YZ125G / 250G / 465G

SHIFT DRUM SEGMENT SCREW

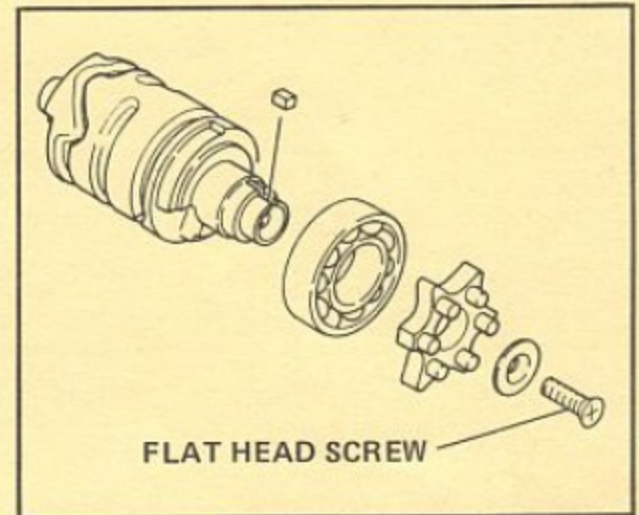
Some of the Affected Models have left the factory without sufficient thread-lock compound on the flat-head screw which holds the star-shaped "segment" to the end of the shift drum. These screws must be reinstalled using adequate thread-lock compound to prevent them from loosening during operation of the machine. Follow the procedure outlined below after uncrating each Affected Model.

1. Drain the oil.
2. Remove the kickstart and shift levers. On YZ250 and YZ465 models, remove the right footpeg and rear brake lever.
3. Remove the clutch cover, clutch pressure plate and clutch assembly.
4. Remove the shift shaft and the flat-head screw which holds the segment to the shift drum.
5. Clean the threads on the flat-head screw and the threads in the shift drum with a nonresidual solvent such as contact point cleaner. Allow to dry.
6. Coat the threads of the screw with a hard thread-lock compound such as red Loctite Stud and Bearing Mount.
7. Reinstall the screw and torque it to 0.8 m-kg (5.8 ft/lbs.).
8. Reassemble using a new clutch cover gasket and fill with the proper amount of SAE 10W30 SE oil. Refer to Bulletin No. M79-080 for revised oil capacity on YZ250 and YZ465 models.
9. Check for proper operation.
